Item Name: Crosstube Turning Detail

DART AEROSPACE LTD	Work Order: 76249
Description: Crosstube Assembly (205/212/412 Low Fwd)	Part Number: D212-664-147
Inspection Dwg: D212-664-147 Rev: B	Page 1 of 1

B	REVISE GENERAL NOTES/PART LIST; UPDATE TO CURRENT STANDARDS; ADD -147B (ZN C4-2, D4-2)	RF	09.09.30
A	NEW ISSUE	CP	07.07.07
REV.	DESCRIPTION	BY	DATE
DESIGN	<u>RF</u>	DART AEROSPACE LTD HAWKESBURY, ONTARIO, CANADA	
DRAWN	<u>RF</u>		
CHECKED	<u>RF</u>		
MFG. APPR.	<u>RF</u>		
APPROVED	<u>RF</u>		
DE APPR.	<u>RF</u>	DRAWING NO. REV. B D212-664-147 SHEET 1 OF 4 TITLE SCALE CROSSTUBE (205/212/412 LOW FWD) NTS	
DATE	09.09.30	COPYRIGHT © 2007 BY DART AEROSPACE LTD. THIS DOCUMENT IS PRIVATE AND CONFIDENTIAL AND IS SUPPLIED ON THE EXPRESS CONDITION THAT IT IS NOT TO BE USED FOR ANY PURPOSE OR COPIES OR COMMUNICATED TO ANY OTHER PERSON WITHOUT WRITTEN PERMISSION FROM DART AEROSPACE LTD.

DRAWING NO. D212-664-147	TITLE CROSSTUBE ASS'Y (205 LOW FWD)	REV. B	DART AEROSPACE LTD ENGINEERING ORDER		D.E.O. NO. D212-664-147-B-1	SHEET NO. SHEET 1 OF 1	SCALE NTS
DRAWN 90	CHECKED ASS	MFG. APPR. 183	APPROVED inf		DE APPR. M		
DATE 11.07.15	DATE 11.07.20	DATE 11.07.21	DATE 11/07/21		DATE 11.07.21

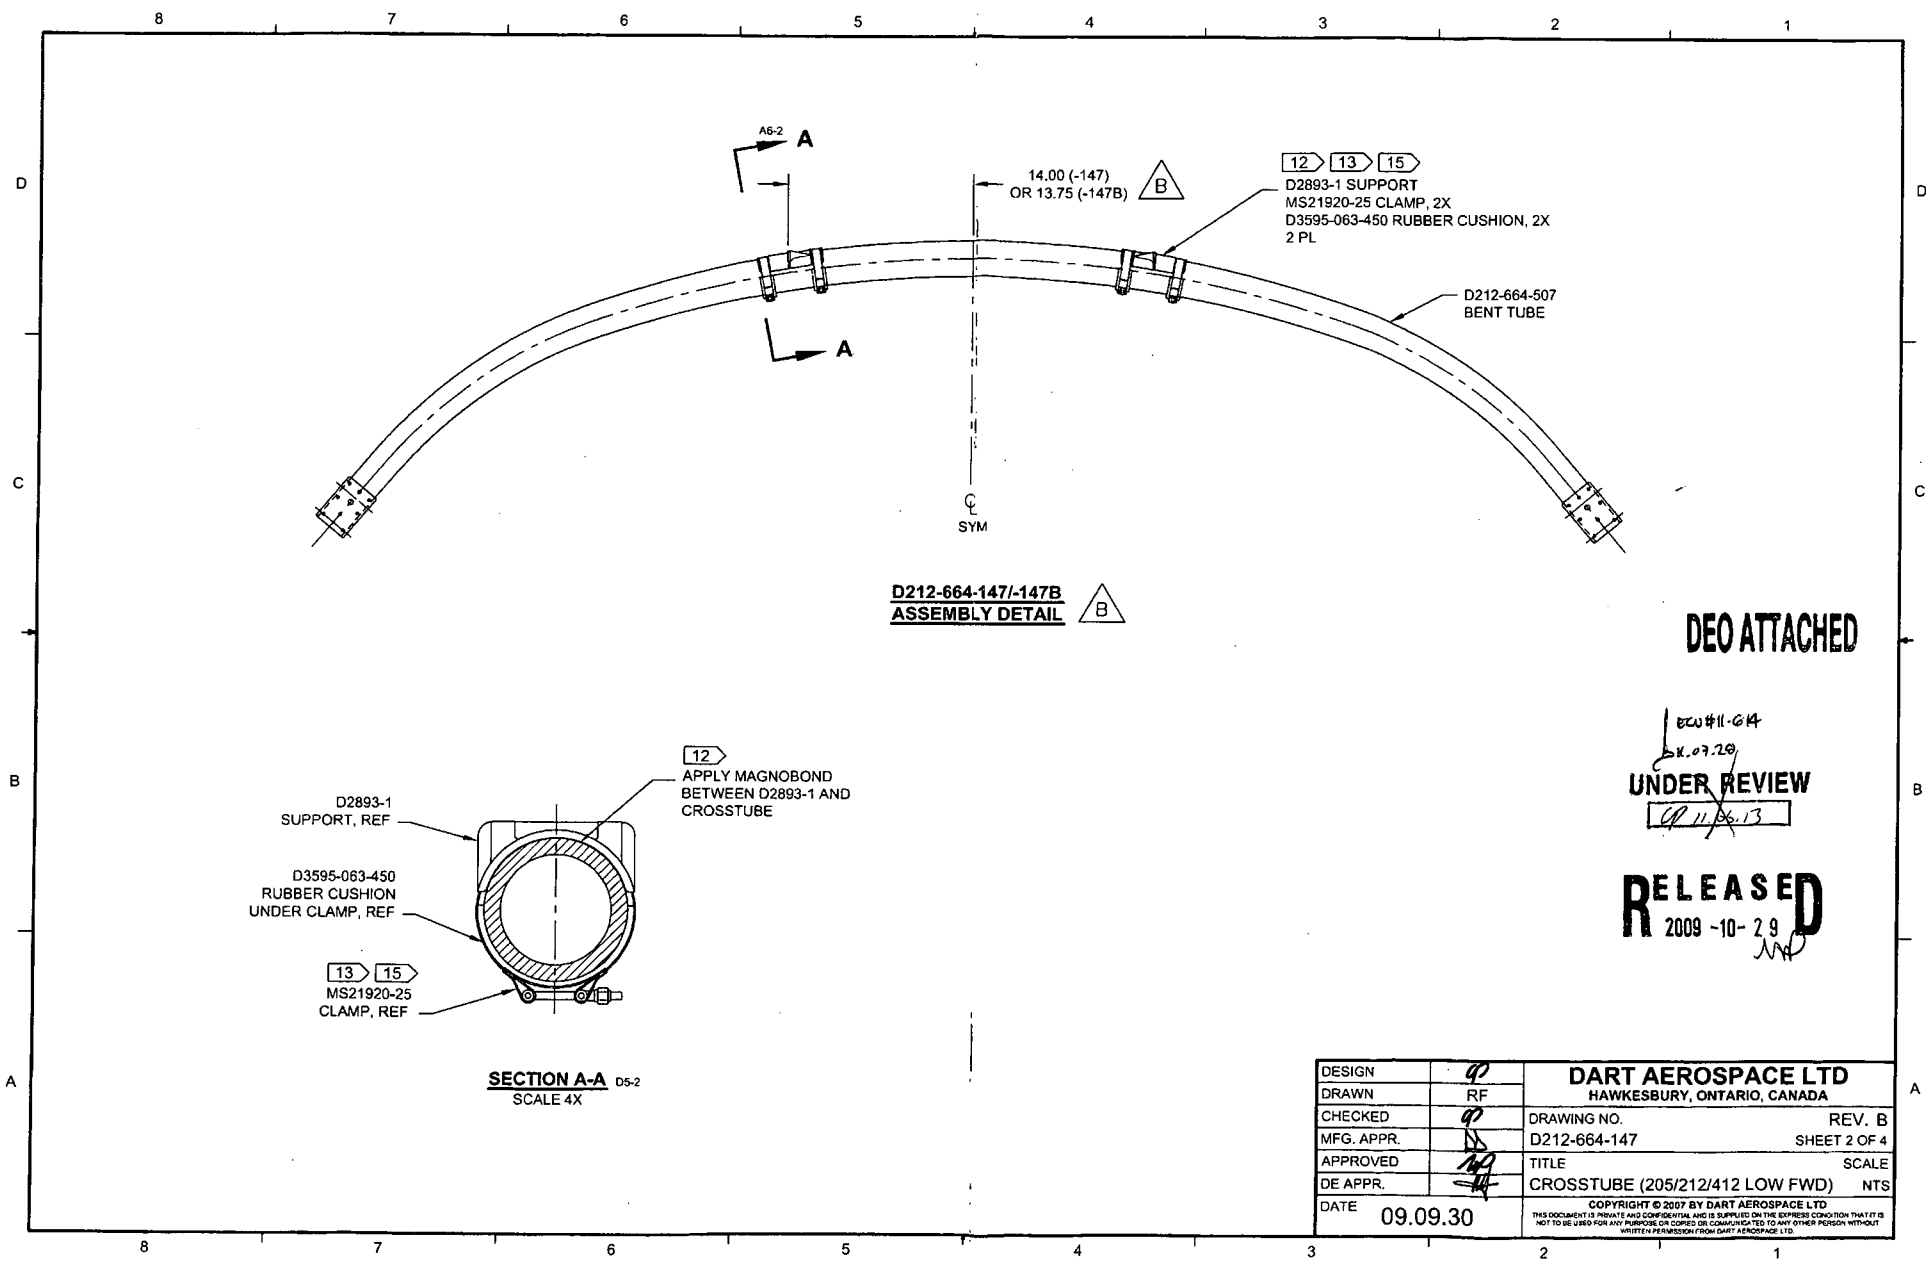
PURPOSE:

REPLACE MAGNOBOND WITH PROSEAL.

NOTE 12 & 15, SHEET 1 IS AMENDED AS FOLLOWS:

WAS:

- 12) INSTALL D2893-1 SUPPORT USING 0.03" TO 0.06" THICK LAYER OF MAGNOBOND 6398 TO THE SURFACE OF D2893-1 THAT WILL BE IN CONTACT WITH THE CROSSTUBE PER QSI 015. LET CURE FOR 12 HOURS AFTER INSTALLATION AND PRIOR TO PACKAGING.
- 15) TORQUE CLAMPS 80 TO 100 IN-LB. ENSURE AT LEAST 1.5 THREADS SHOWING IN SAFETY AND THAT NUT HAS NOT BOTTOMED-OUT AFTER TORQUING.

Item	Qty -147	Qty -147B	Part Number	Description
9	A/R	A/R	PROSEAL 890 B-2	SEALANT, AMS-S-8802 CLASS B-2

- 12) TO INSTALL D2893-1 SUPPORT: ABRASE MATING SURFACE OF SUPPORT AND CROSSTUBE WITH 180-GRIT SANDPAPER AND REMOVE RESIDUE WITH MEK (OR EQUIVALENT). APPLY A 0.04" TO 0.07" THICK LAYER OF PROSEAL 890 CLASS B-2 (OR AMS-S-8802 CLASS B-2) SEALANT TO MATING SURFACE OF SUPPORT.
- 15) TORQUE CLAMPS 80 TO 100 IN-LB. ENSURE AT LEAST 1.5 THREADS SHOWING IN SAFETY AND THAT NUT HAS NOT BOTTOMED-OUT AFTER TORQUING. **PRIOR TO PACKAGING, RE-CHECK TORQUE ON CLAMPS AFTER PROSEAL 890 SEALANT HAS CURED FOR 72 HOURS.**
